**ZONING MAP CHANGE
STAFF REPORT**

City Council Meeting Date:
December 15, 2020

Site Location: 5400 & 5420 E. Rosedale Street Acreage: 5.11

Proposed Use: Required Plan for PD 1262

SP100

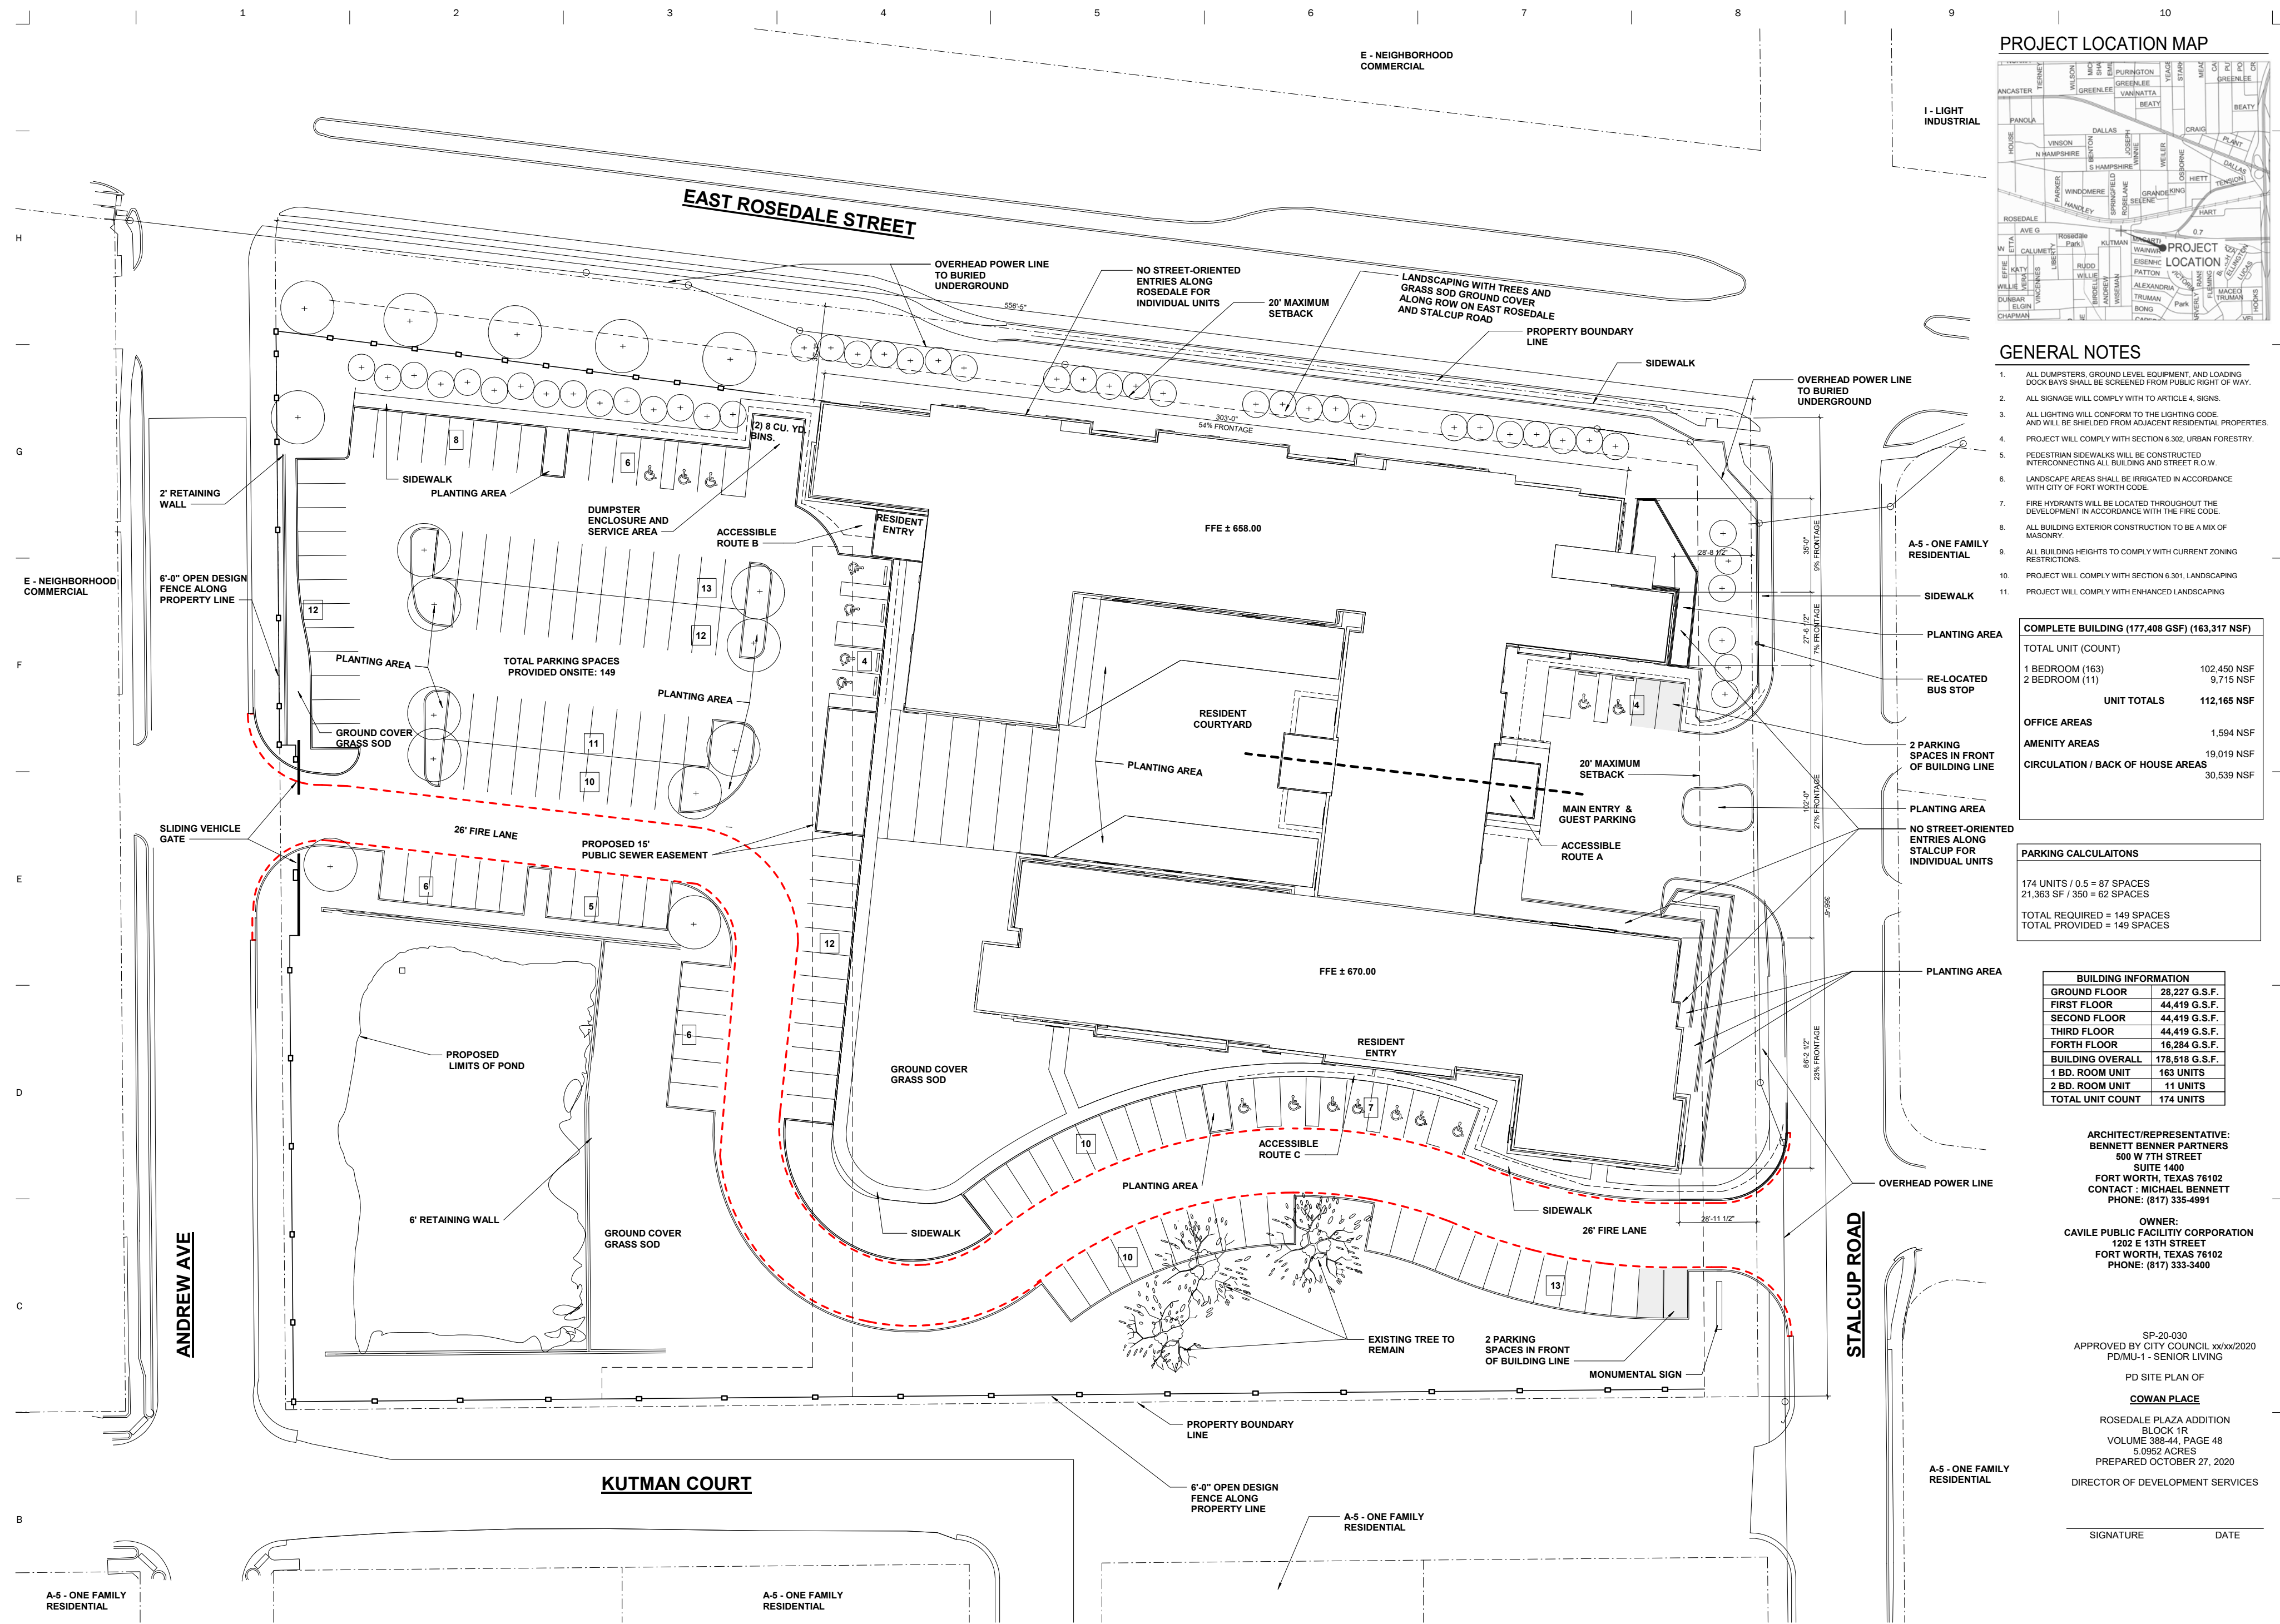
The site plan as submitted is not in general compliance with the Zoning Ordinance regulations.

1. The applicant is requesting a waiver from the maximum setback requirement for both the primary and side street frontages. The MU-1 ordinance requires a maximum setback of 20' along the primary and side street frontages. **(Revised Regulation Required)**

2. The applicant is requesting a waiver from primary street frontage requirement. The MU-1 ordinance requires buildings be located within the allowed setback area for a minimum of 50% of the primary street frontage. **(Revised Regulation Required)**

3. The applicant is requesting a waiver from the surface parking location requirement. The MU-1 ordinance does not allow for any surface parking space to be located between the building front and street. **(Revised Regulation Required)**

4. The applicant is requesting a waiver from the screening requirements and location of service areas. The MU-1 ordinance requires apartments with street level units provide individual street-oriented entry for each unit along a street frontage. **(Revised Regulation Required)**

- a. *The applicant has indicated that the additional setback is needed for clearance from existing overhead electrical lines that are along these frontages. Staff recommends approval.*

- a. *The applicant has indicated that they are intending to have 30% of the building in this location in order to allow for a guest entry court. While this is not an ideal location for parking, staff feels the location will not have a significant effect on the surrounding uses or public realm.*

- a. *The applicant is requesting four (4) parking spaces between the front of the building on Stalcup Road. Since Stalcup Road is the primary street for this development, the portion of the building facing this street is considered the front of the building. Because these spaces are located within a front entry courtyard, these spaces will have minimal impact on the pedestrian realm.*

- a. *The applicant has indicated that they are proposing to have all of the units have entries that are located internal to the development for additional building security. Staff does not have any concerns with this request*
